March 9, 2012

Re: **Errata and Clarification Document for the Application for Type A Water License for the Mary River Project**

Attachment 5: Missing Drawings and/or Re-issued Drawings

Figure 1- 1: Quarry Q7 + 500 Site Layout

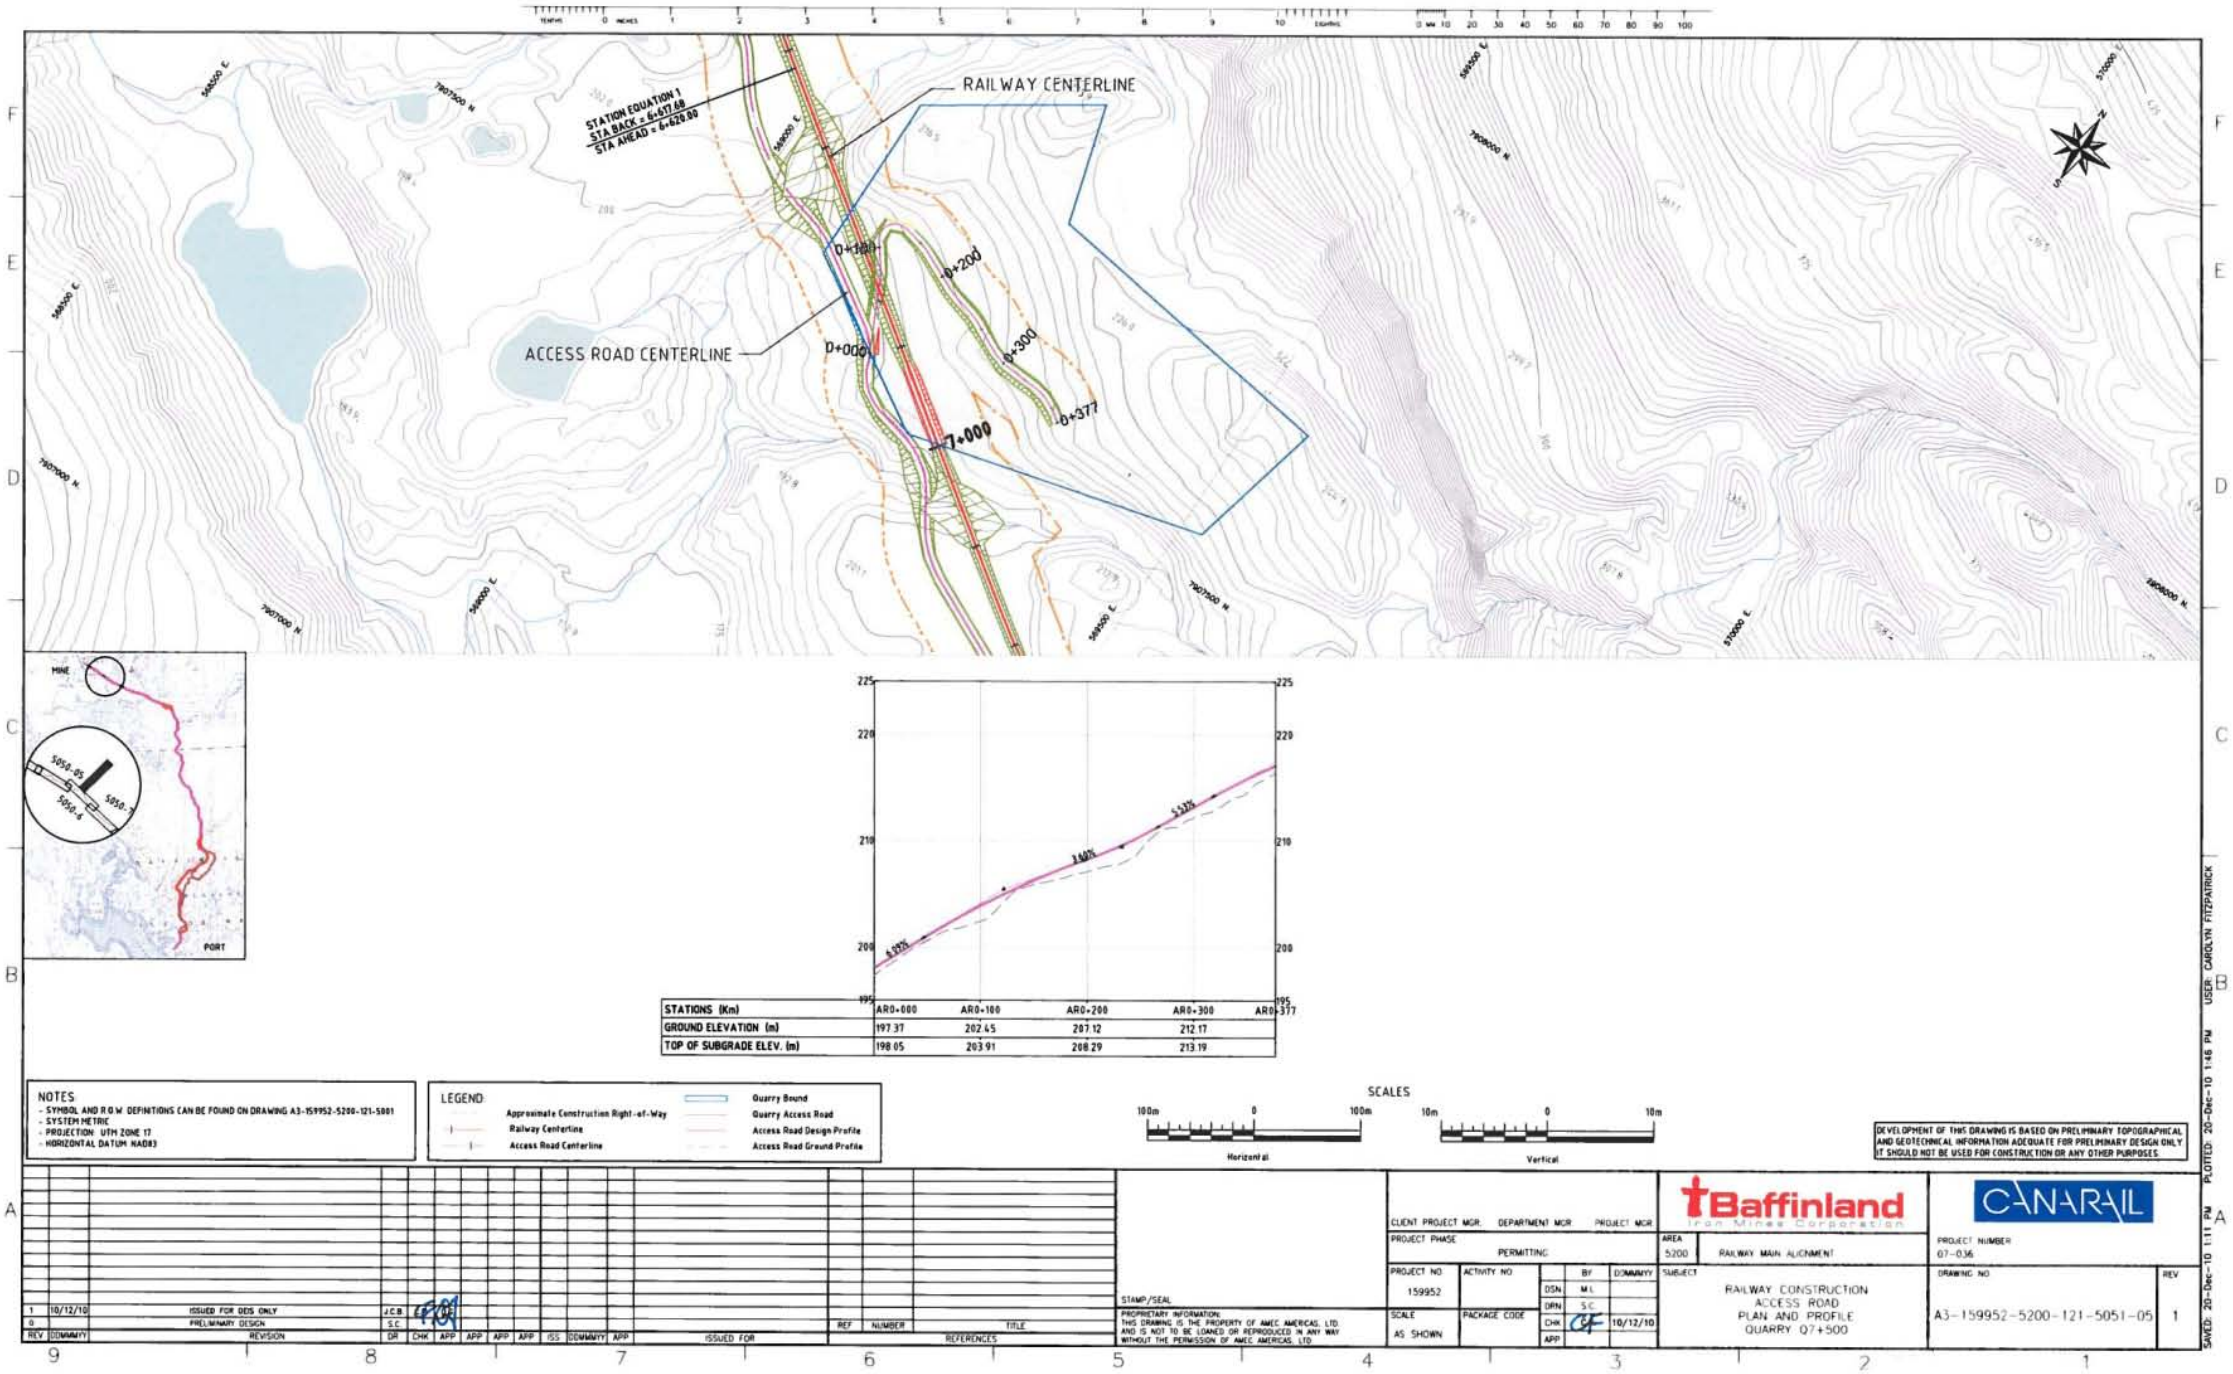
Milne Inlet	Milne Inlet Quarry Site Layout	H3337697-7000-10-014-1110	Is there any particular reason as to why a stamped copy of this drawing is not included under Attachment 9, Appendix 3B?	To avoid repetition this drawing was only included in Attachment 6- Operations and Management Plan Milne Inlet Quarry, and not in Attachment 9. Therefore this drawing did not require a stamp
Mary River Mine site	Mine sit Quarry Site Layout	H3337697-7000-10-014-1111	Is there any particular reason as to why a stamped copy of this drawing is not included under Attachment 9, Appendix 3B?	To avoid repetition this drawing was only included in Attachment 6- Operations and Management Plan Mine Site Quarry, and not in Attachment 9. Therefore this drawing did not require a stamp
Misc.	Quarry Q7-500, Q133-500, Q77-200	Drawing numbers not legible	Is there any particular reason as to why stamped copies of these drawings are not included under Attachment 9, Appendix 3B?	These drawings are provided in this Errata document on 11X17 paper size to improve image quality. These drawings were included only in the individual rail Quarry sites and not in Attachment 9 to avoid repetition and therefore do not require a stamp.
